From the Comm. Architect No 798 of 18th January 1882.

Breadth of Verandah for
Standard design of Sub Judge
and Munsiff's Court.

The standard plans of sub-judges' and district munsiffs' court-houses, approved in O.G. No. 2294 W dated 6th September 1879, are forwarded for the Honble Member's inspection, with reference to a remark made by him on a draft order lately returned from circulation.

SECTION OF VERANDAH.
JUDGES CUTCHERRY. SALEM.

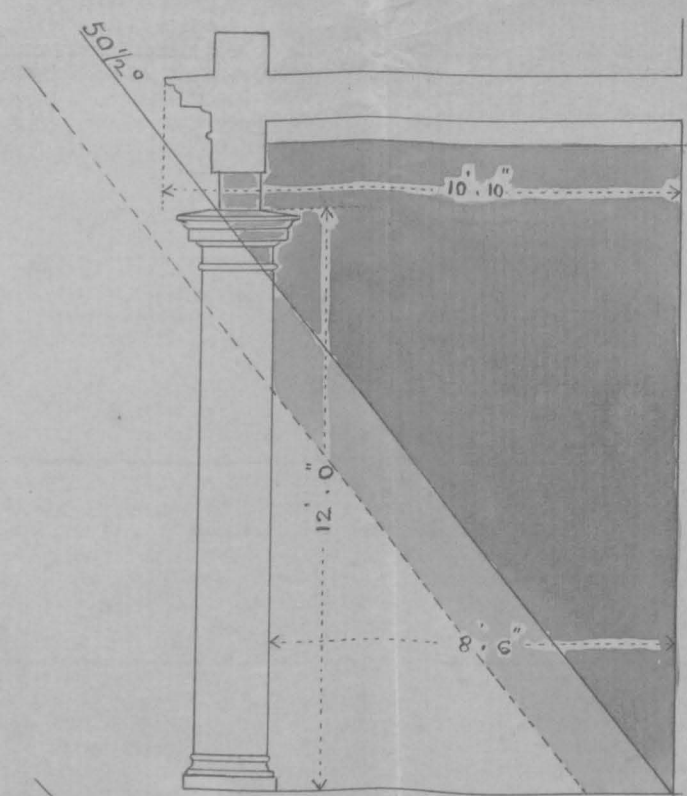
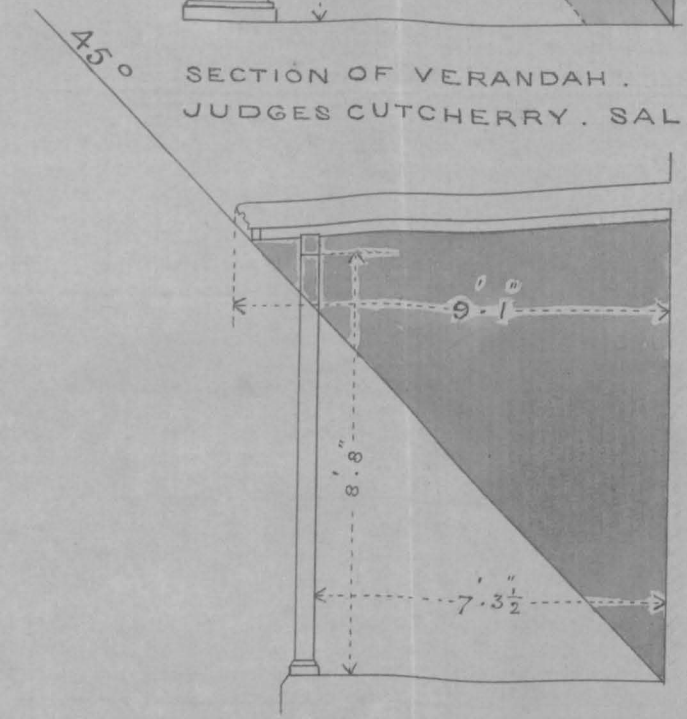
I confess I do not like a verandah less than 10 ft. which is practically that of the old type given by the enclosure 8'6" + 1'6" diam. of columns.

As being the present standard plan. I find there is more protection than I thought. I know the matter in the C.S. lands. Probably it is as good as the standard plan rather the standard plan.

As shown the standard design since my recollection is that they have no verandahs at all. Perhaps the design has been altered. M

In the particular case in question I have compared the Standard plan with the Verandah of the Judges Court at Salem. I selected this Verandah as a fair Typical form after inspecting numerous Verandahs in various parts of the country. In a Verandah lying true north and south and a maximum diurnal duration the sunshine would clear the main wall of the Standard plan about 22 minutes sooner than the Typical plan. 7 or 8 feet is ample breadth for a corridor, and ample as the diagrams will show to secure shade. Any breadth over this therefore not only represents useless expenditure but becomes a source of continual temptation to the owner or occupier. The desire to utilize what must be regarded as waste space is so great, that nearly every Verandah over 10 ft is closed and made into a room. It is unnecessary to point out that this arrangement is more objectionable than building originally without Verandahs at all.

Just being of opinion that the Standard plans of Subjudgets & district magistrates' Court houses, approved for adoption in O.F. No. 2294 W. dated 6th Sept. 1879, have the defect of insufficient protection from the Sun, and need to be revised in that respect, the asst. has the honor to request that the attention of the Cons. Architect to the matter, and to ask for such explanation as Mr. Disbrow may wish to offer.

comparison between the
Standard design and
previous designs might,
the Chief Engineer think,
be obtained by placing
side by side sections
of the veranda allowed
in the Standard design
and in typical examples
from buildings of the
old style with columns
& architraves, showing
the shadow line for
the same angle in
each respectively of
the two elevations.

No alteration of standard
plant needed.
plain *new* *Att*
